12-20 VICTORIA CRESCENT ABBOTSFORD VIC 3067 AUSTRALIA

TOWN PLANNING APPLICATION

PROJECT NO. 170033

SOUTH ELEVATION
SCALE 1:200 (A1)

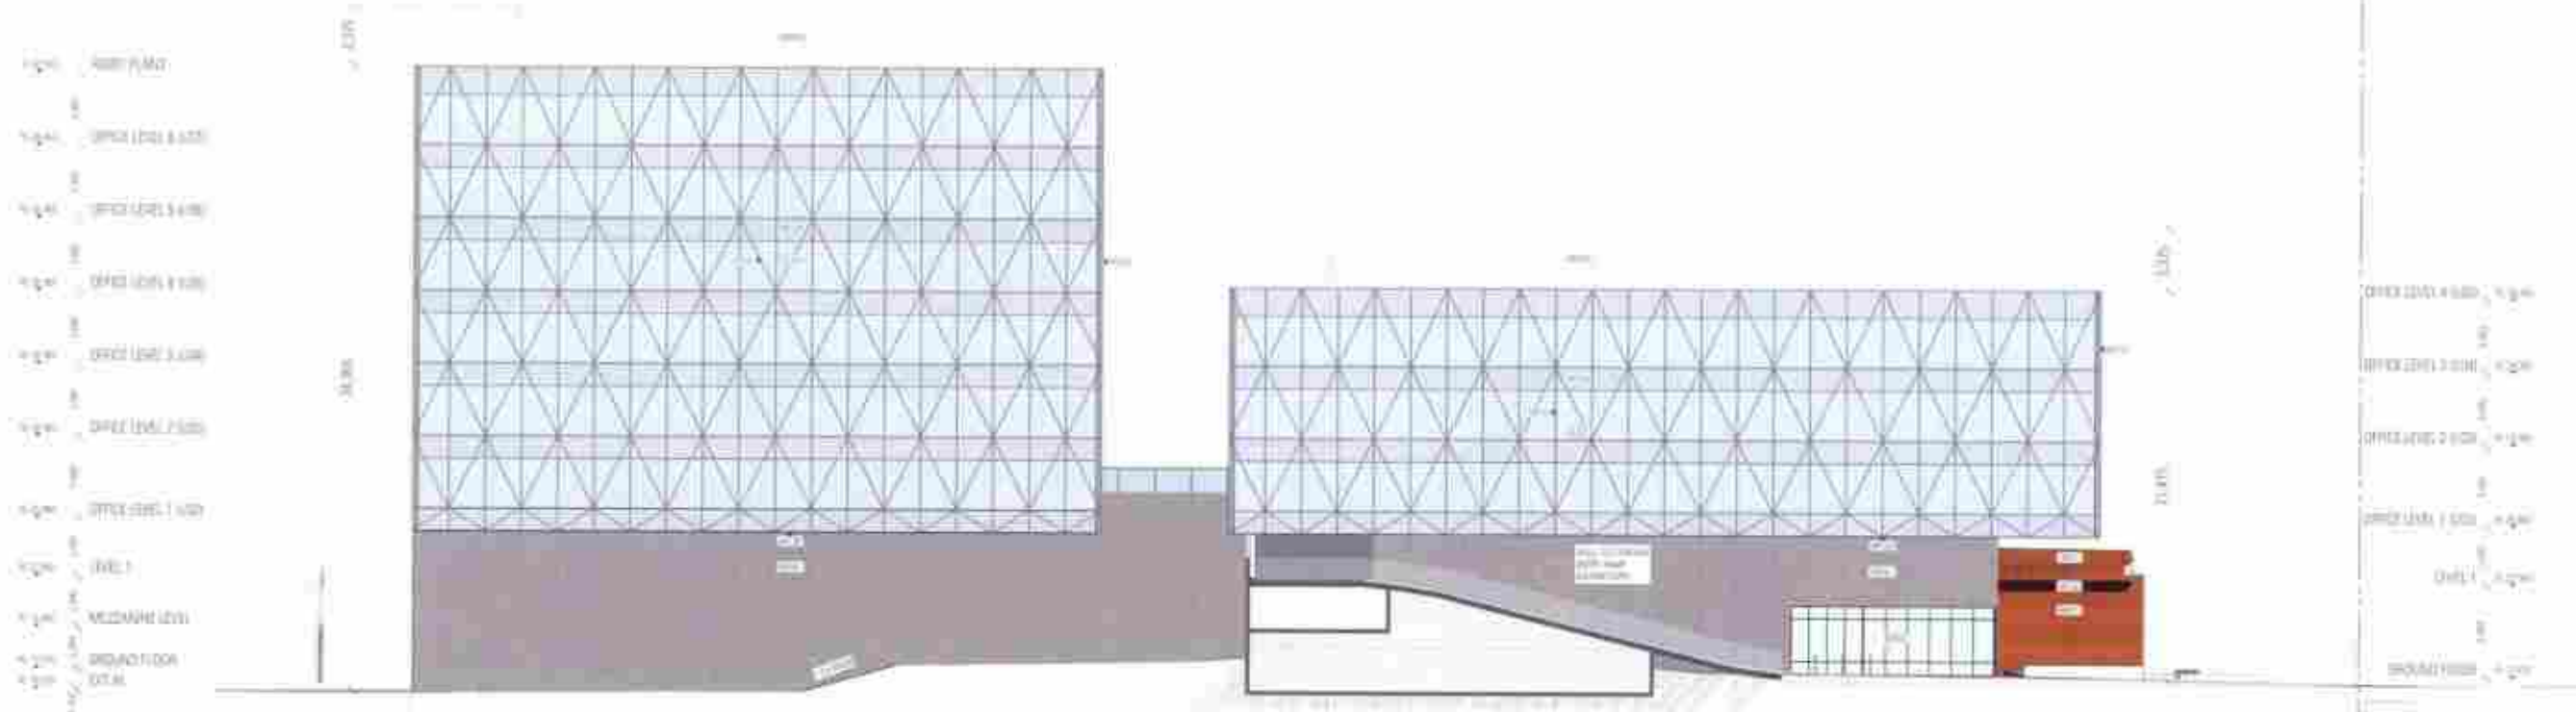
Item	Details
<p>South Elevation Drawing</p>	<p>The South Elevation drawing appears to show an inaccurate depiction of the development.</p> <p>Is it unclear why there is a ramp shown in the laneway. The applicant is to provide details and function of this ramp.</p> <p>The vehicle access point and other building features are not depicted on the drawings.</p>  <p>Where are the vehicle access point and service cabinet doors along the south side of the building?</p> <p>What is the purpose of the ramp shown in the South Elevation drawing?</p>
<p>Setback Area – Unnamed Laneway</p>	<p>The setback area of 2.39 metres (inside the property) should be constructed in a different material to the bluestone open channel.</p>

Corner Splay

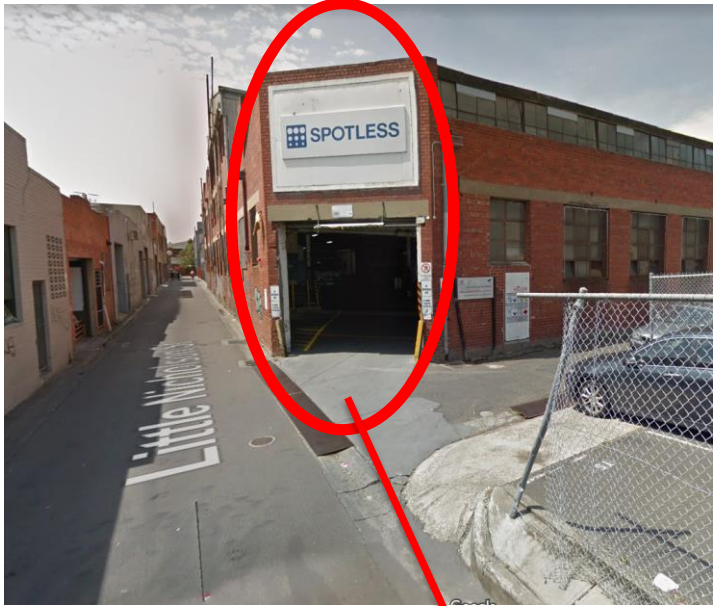
Existing splay to remain intact on the ground level and not occupied by the development

Reconstruction of Unnamed Laneway

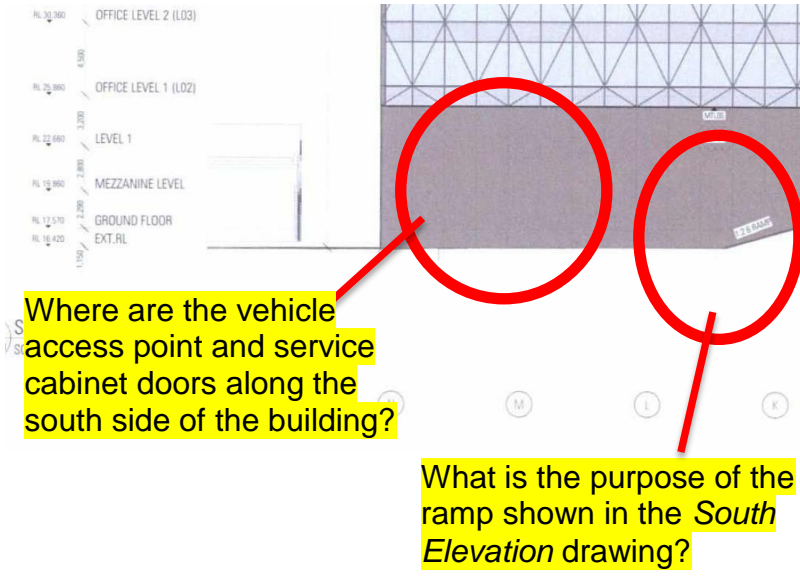
The laneway is to be reconstructed to Council's satisfaction and at the Permit Holder's cost, and Australian Standards. Vehicle access to abutting properties must be maintained and designed for a B99 design vehicle.

All metal plates located in the laneway must be removed.

Diagram 1

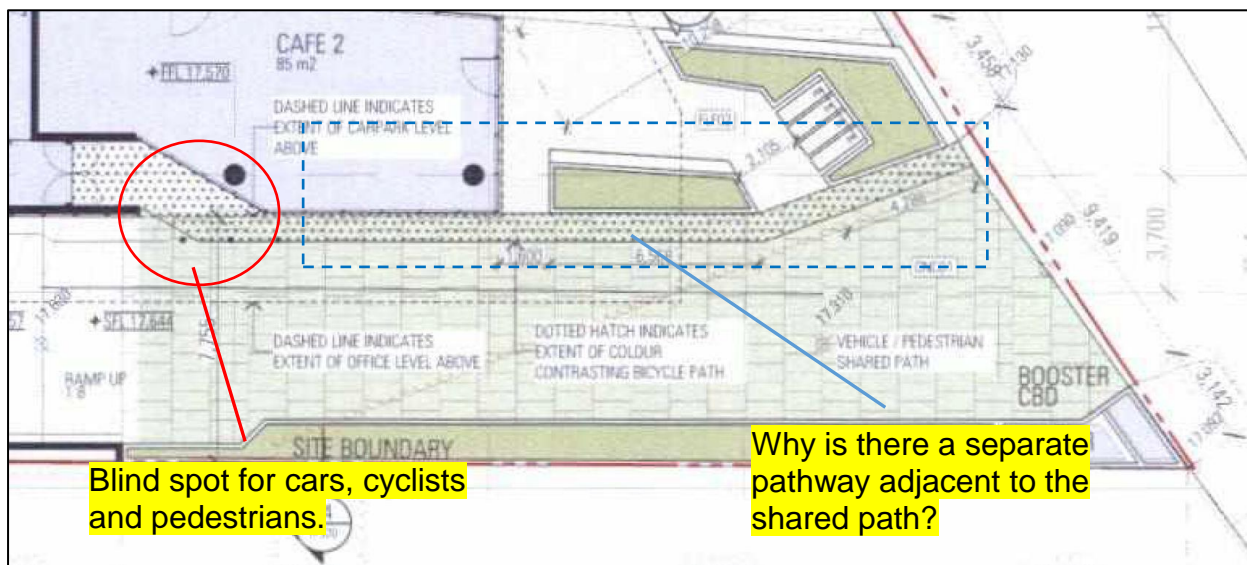
<i>Pedestrian/Vehicle Shared Path off Victoria Crescent</i>	<i>The applicant is to provide an explanation on the purpose of the separate pathway to the EOT Bike Parking, which is adjacent to the Vehicle/Pedestrian Shared Path.</i> <i>What is the speed limit inside the shared path and how will the applicant improve the blind spot/conflict point at the entrance to the EOT Bike Parking – see Diagram 1.</i>

Figure 2 – Indicates a blindspot and likely conflict between vehicles and pedestrians/cyclists.

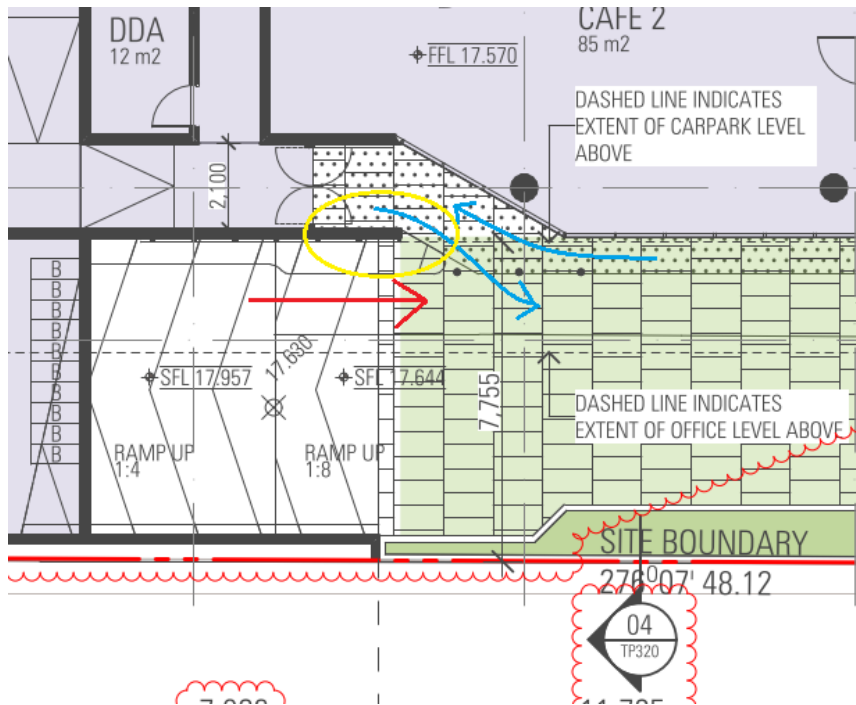
Vehicle/Cyclist blind-spot

The current design of the vehicle ramp/cyclist entrance creates a blind-spot likely to result in conflict between vehicles and cyclists or pedestrians. In instances where cyclists/pedestrians are entering the building at the same time a cyclist/pedestrian is exiting, the exiting cyclists will be forced onto the driveway close to the top of the ramp. A solid wall sits between the vehicle ramp and cyclists entrance which acts as a blind-spot increasing the likelihood of conflict in this situation (Figure 2).

Figure 3 – The spaces circled could be converted to more accessible horizontal at-grade level spaces without contravening the requirements of AS2890.3 or unduly compromising access to any of the spaces.

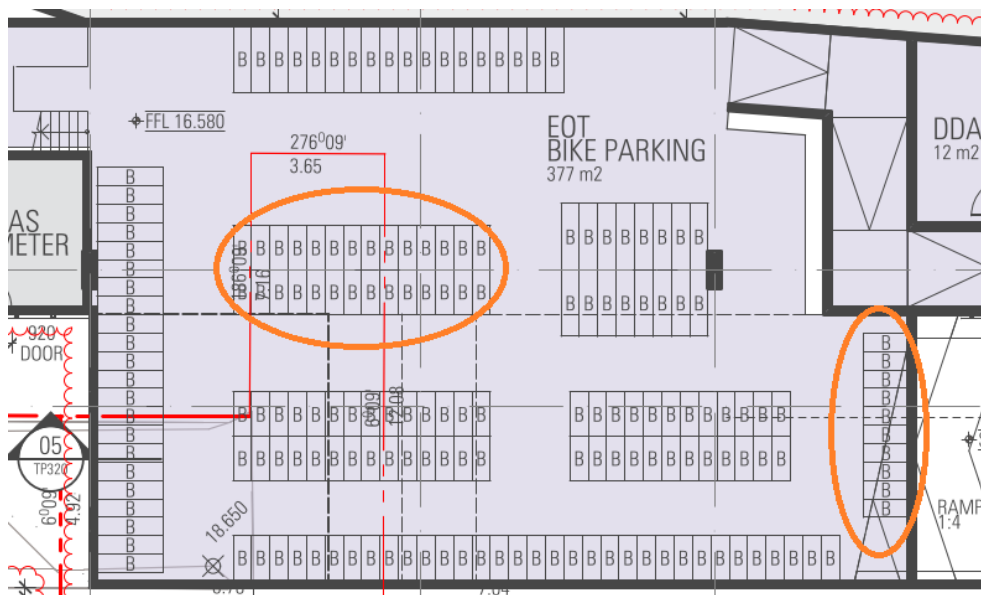
Despite the above, it is recommended a higher percentage of horizontal spaces are provided. The existing layout of the bicycle storage area would allow an additional 38 spaces to be provided as horizontal spaces, without contravening the requirements of AS2890.3 (Figure 3). In practice horizontal spaces are far more utilised than hanging spaces in any given storage space.

- The 38 bicycle spaces identified in Figure 3 which currently appear to be hanging spaces provided as horizontal, at-grade spaces.
